NOTICE UNDER SECTION 96 (1) CHAPTER IX OF THE BOMBAY  
DISTRICT MUNICIPAL ACT III OF 1901 AS MODIFIED  
UPTO THE END OF 1930

Pursuant to the provision of Section 96 of the Bombay District Municipal Act III of 1901 I hereby give you notice that I intend with the meaning of that Section to erect a building on plot No. 37/1 Survey Sheet J.M. 3. situated in Hyd. Aml. C. H. Street Jamshed Quarter as per Ground plan, Elevation and Section sent herewith in quadruplicate.

With reference to your application dated 23-3-34  
with a plan for the proposed building/additions and alterations on plot  
No. 37/1, Survey Sheet No. J. K. 3, Jamsheed Quarter  
I have to request you to comply with the following requirements:—

## PLAN FOR PROPOSED BUNGALOW ON

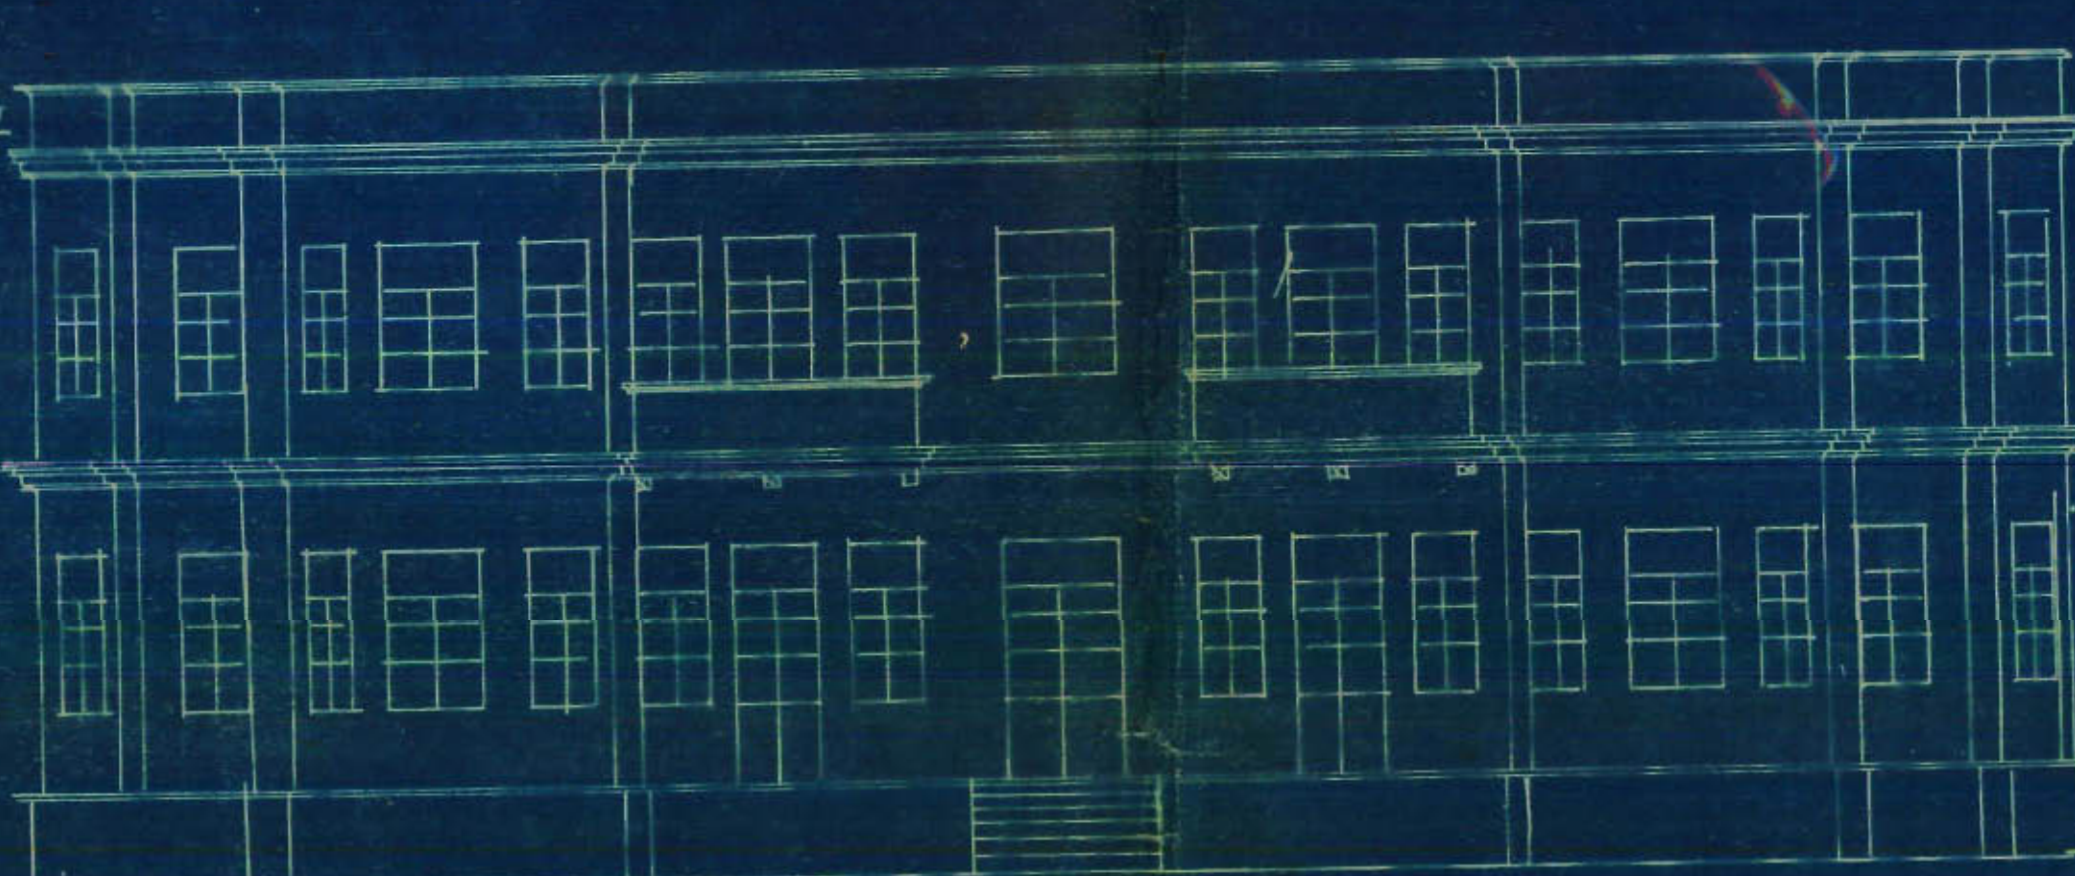
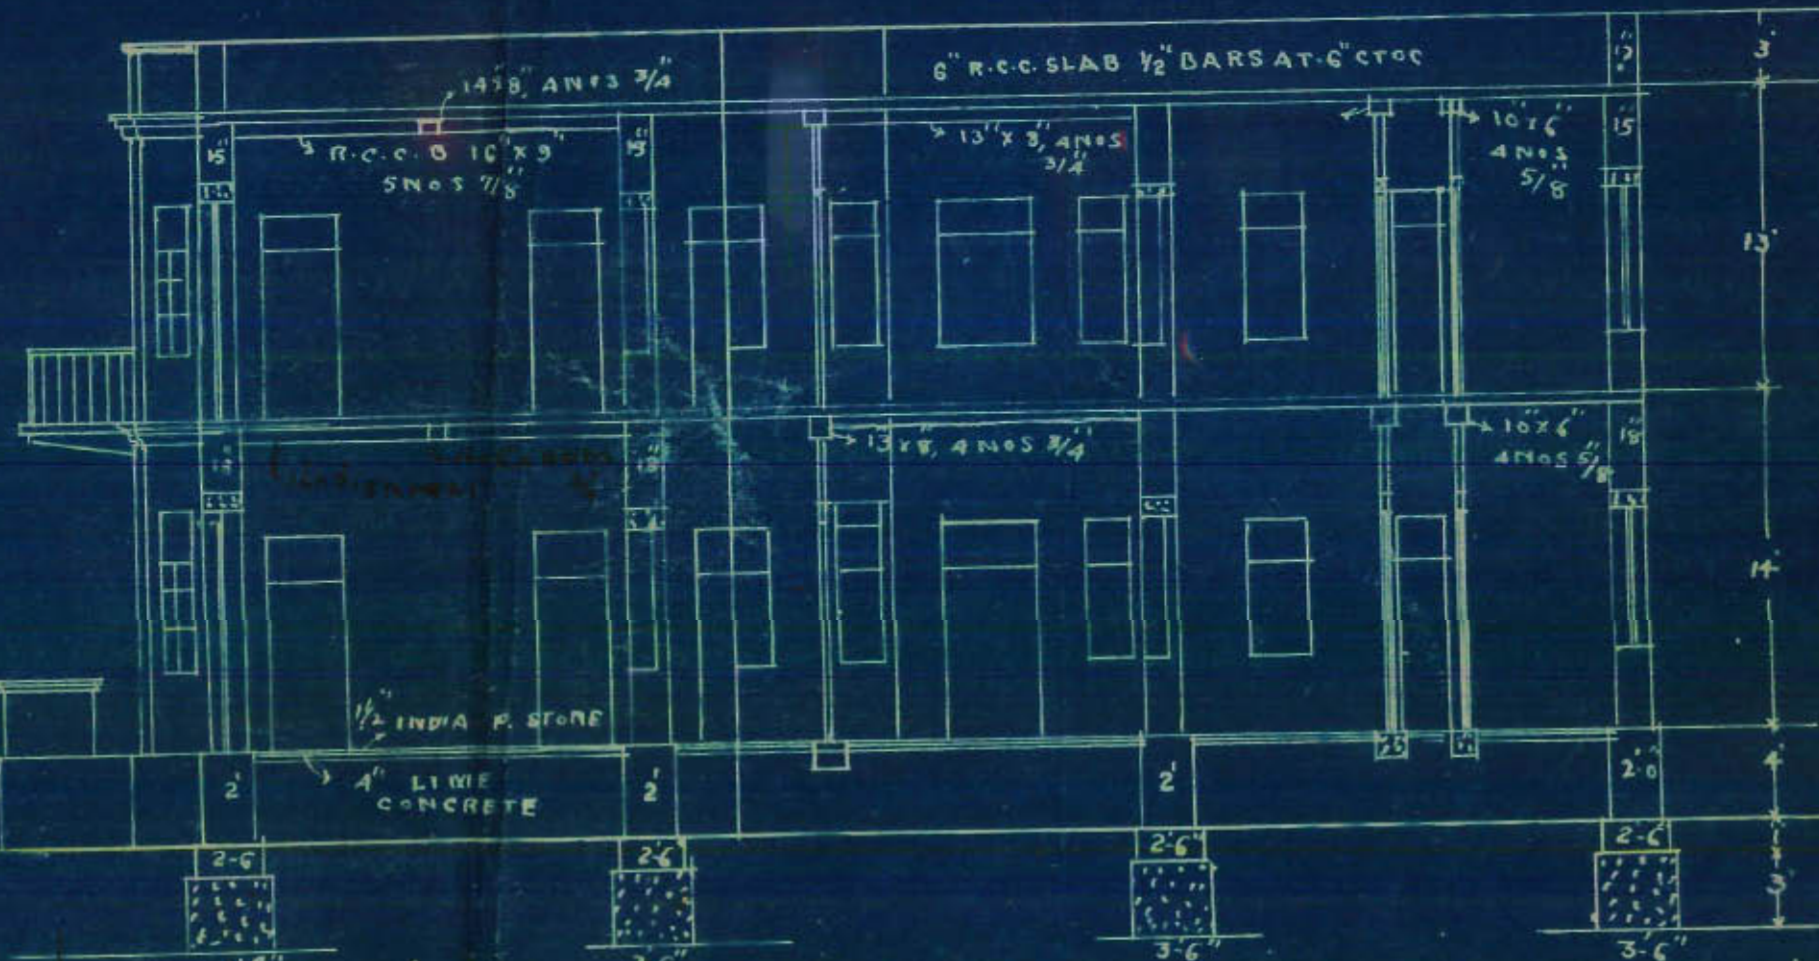
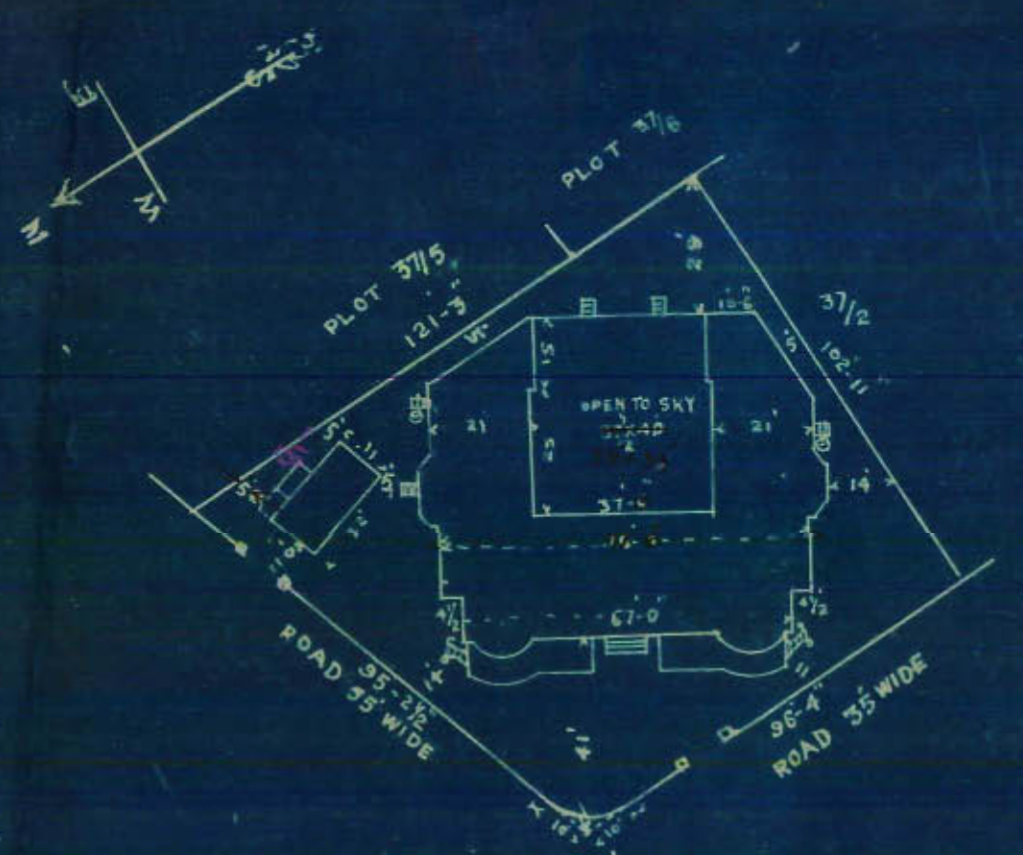
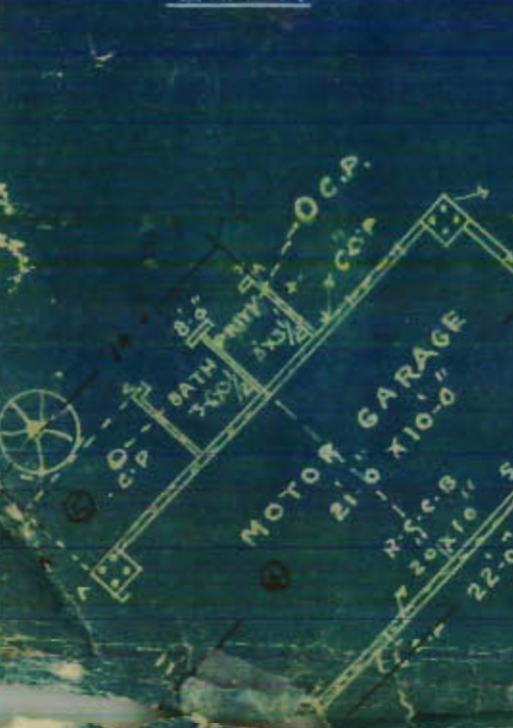
- Section requires correction :- Balcony on 1st floor is not shown*
- (1) Open Thala on ground floor must show the parapet line as shown in the section. Steps are not shown in elevation.

- (2) The section must show depths of foundations & heights of floors & plinth.
  - (3) winding stairs & sanitary block <sup>of the garage section</sup> must be 5 ft away from the boundary of the plot.

- (4) Section of the garage must be given showing the heights of floors clearly.
  - (5) Staircase must be fireproofed.
  - (6) Compound wall with section, position of gate etc be given.

- (7) This internal walls of WC must be <sup>at least</sup> 6" C.P.
  - (8) ~~Garage passages be dimensioned~~ <sup>and their</sup> railing be specified.

- (9) Privies & cesspits will be allowed.
  - (10) The measurements taken into calculating the built up area do not tally with those arrived at by the additions of the dimensions put on the plan.

- It thus follows that the built up area worked out by the architect is wrong.*
- (11) Some of the structures have to be dimensioned completely so that their areas be checked

*Submitted.  
Objections are  
complied. Plans may  
be approved*

PLAN FOR PROPOSED BUNGALOW ON  
PLOT NO. 374 SHEET NO. J.M.3.  
XMI. CO. HO. SOCIETY

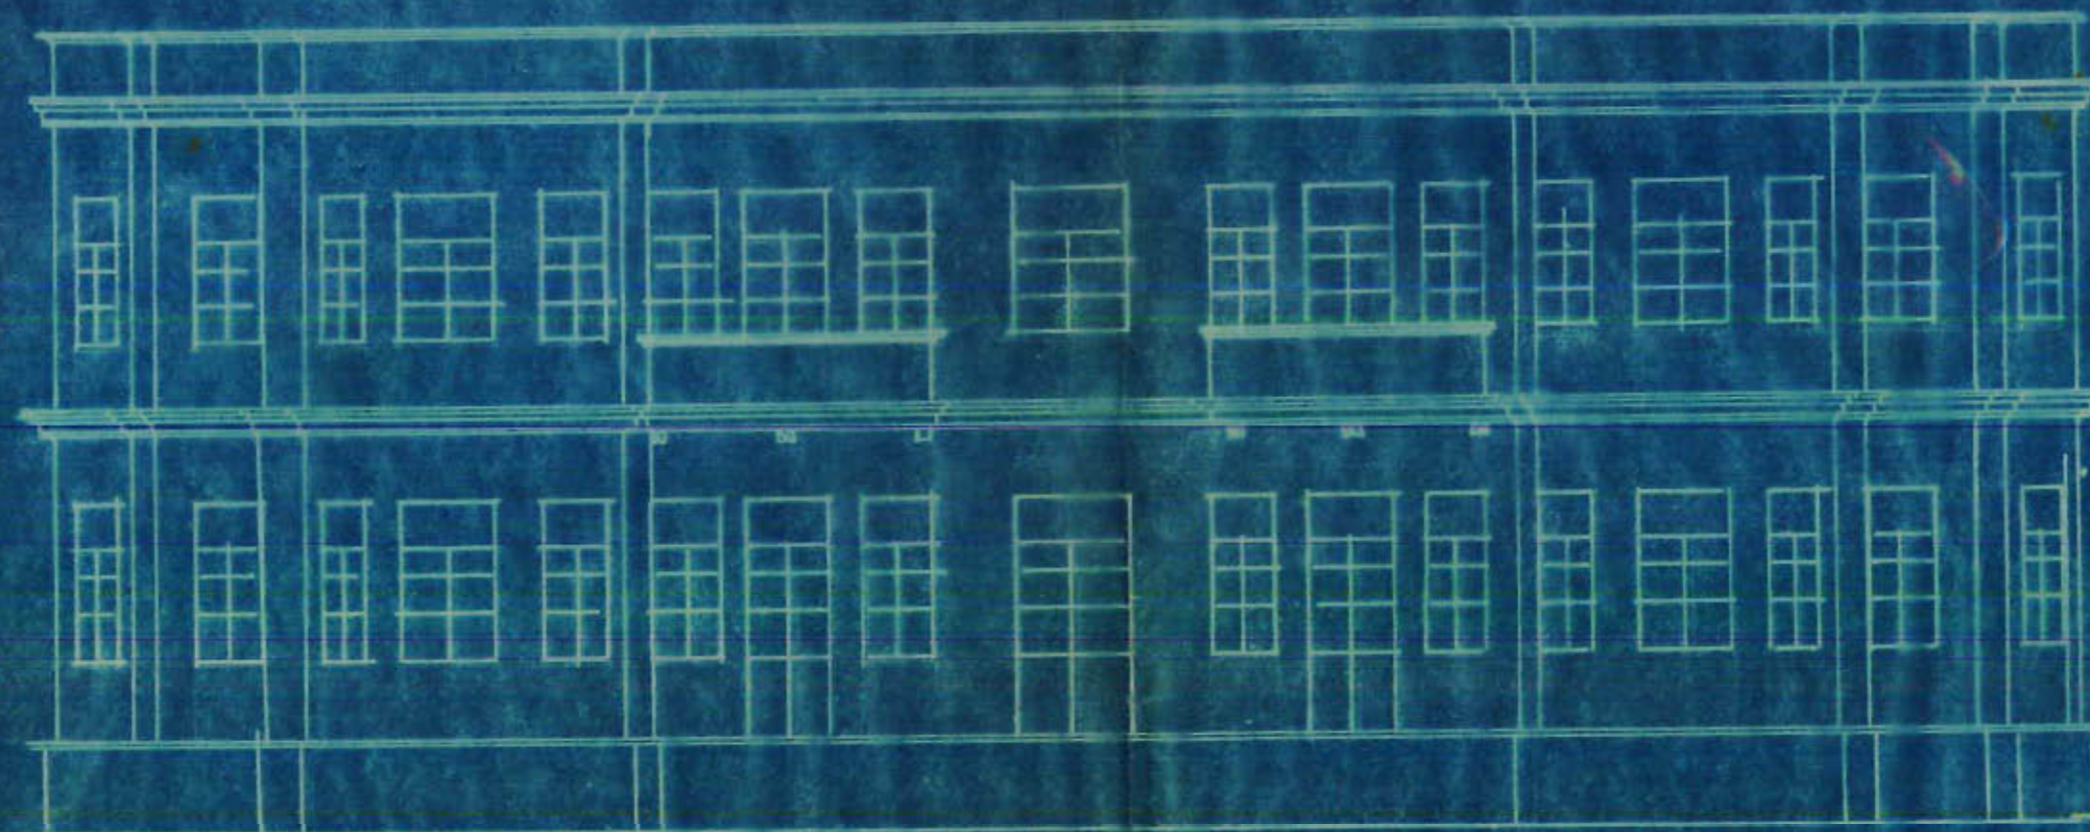
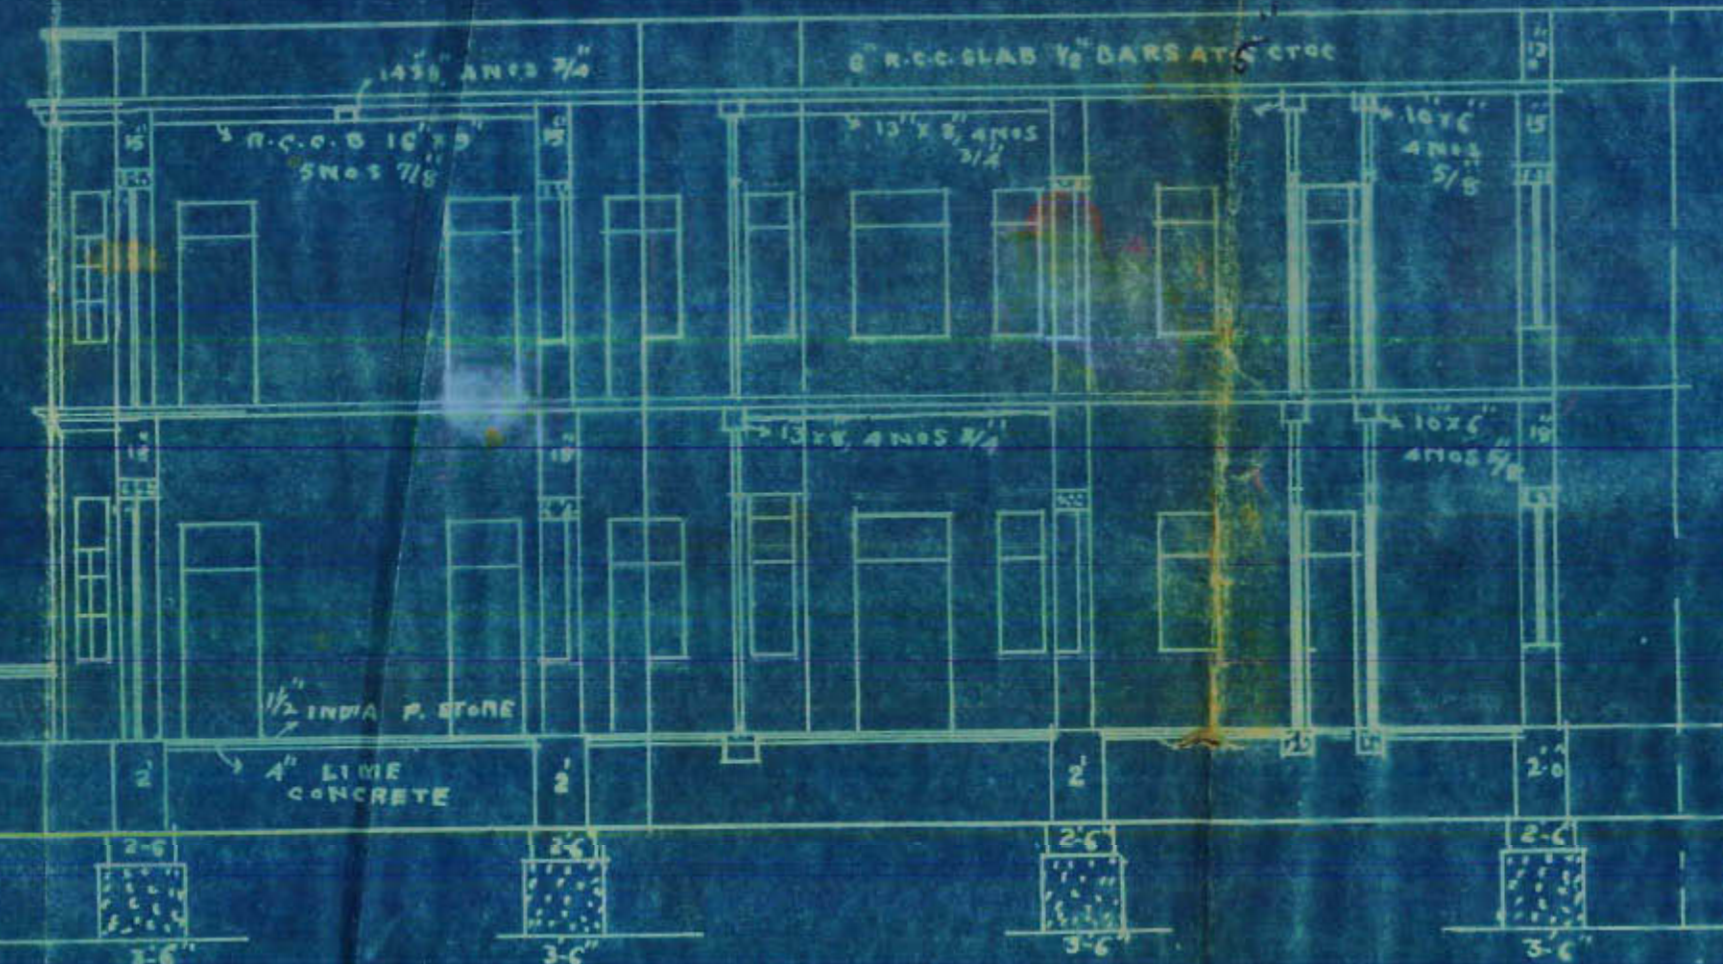
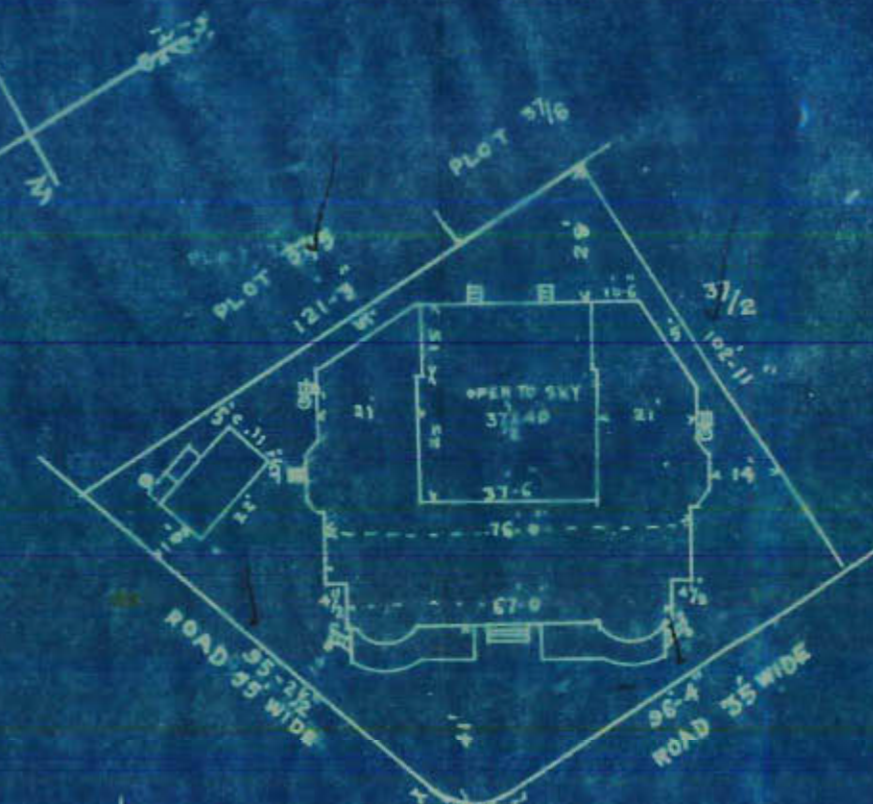
- ✓ 1. There is no drainage in this area hence W.C.s cannot be permitted. *Privies with cesspits as shown in plan will be allowed.*
- ✓ 2. Section requires correction. Balcony on 1st floor is not shown. Open Thala on ground floor must show the parapet line as shown in the section. Steps are not shown in elevation.

- ✓ 3. The section must show depths of foundations and heights of floors and plinth.
- ✓ 4. Winding stairs and sanitary block of the garage section must be 5ft away from the boundary of the plot.

- ✓ 5. Section of the garage must be given showing the heights of floors clearly.
- ✓ 6. Staircase must be fireproofed.
- ✓ 7. Compound wall with section, position of gates etc be given.

- ✓ 8. Thin external walls of W.C.s must be at least 6" c.p.
- ✓ 9. Gallery passage railing be specified.
- ✓ 10. Privies and cesspits will be allowed.
- ✓ 11. The measurements taken into calculation the built up area do not tally with those arrived at by the additions of their dimensions put on the plan.

The plans are returned herewith rejected. *and so on.*  
it thus follows that the built up area worked out by the architect is wrong.
12. Some of the structures have to be dimensioned completely so that the areas be checked.

The Plans which accompanied your letter of the 24th  
ultimo, are returned herewith after due compliance, for favour of a  
very early sanction. Thanking you,
